# Access Compliance Report

## Public Rights-of-Way

### (Curb Ramps)

Intersection ID: 30211	Main Street: BRISTLE_LN	Cross Street: HIDDEN_CREEK_DR	Location:	N
ADA ID: 2D84C93E0811	Ramp Type: BlendTrans1	Initial Pass/Fail: Fail	Overall Compliance: No	Severity Score: 8.75
Codes/Mitigation Info/Possible Solution		Field Measurements/Component Compliance

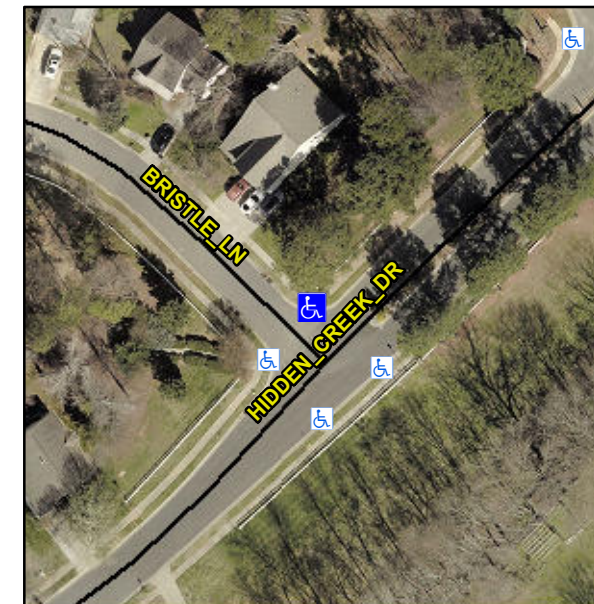
Compliance	Description	Data	Compliance	Description	Data
N/A	Ramp Length (in)	48.0	Yes	BlendTrans Slope (%)	2.5
No	Ramp Width (in)	46.5	Yes	BlendTrans XSlope (%)	1.8
N/A	Flare Type LT	N/A	N/A	Flare Type RT	N/A
N/A	Flare Slope LT (%)	N/A	N/A	Flare Slope RT (%)	N/A
N/A	Flare Traversable LT?	N/A	N/A	Flare Traversable RT?	N/A
N/A	Landing Length (in)	N/A	N/A	DWS Provided?	N/A
N/A	Landing Width (in)	N/A	N/A	DWS Contrast?	N/A
N/A	Landing Slope (%)	N/A	N/A	DWS Length (in)	N/A
N/A	Landing X Slope (%)	N/A	N/A	DWS Full Width?	N/A
N/A	Landing Curb? (Y/N)	N/A	N/A	DWS Offset (in)	N/A
N/A	Shared Landing?	N/A			
N/A	Gutter Ponding?	N/A	N/A	Gutter Slope (%)	N/A
N/A	Gutter Lip Ht (in)	N/A	N/A	Gutter X Slope (%)	N/A
N/A	Painted X Walk1?	No	N/A	Painted X Walk2?	No
	X Walk 1 Direction	To SW		X Walk 2 Direction	To SE
	X Walk 1 Width (in)	N/A		X Walk 2 Width (in)	N/A
	X Walk 1 Slope (%)	3.6		X Walk 2 Slope (%)	0.2
	X Walk 1 X Slope (%)	1.5		X Walk 2 X Slope (%)	2.2

N/A	Ramp inside XWalk1?	N/A	N/A	Ramp inside XWalk2?	N/A
	Road Slope (%)	1.4		Clear Space?	N/A
	Road X Slope (%)	2.9	N/A	Clear Space to XWalk (in)	N/A
N/A	Any Obstructions?	N/A	N/A	Storm Grate/Utility Hazard?	N/A
	Obstruction Type			Storm Grate/Utility Type	
		N/A			N/A
			Yes	Surface Condition? (G/P)	Good
			N/A	Curb Slope (%)	4.8

**Remove & Replace Curb Ramp With Two New Directional Ramps or Equivalent.**

**R304.5.1**
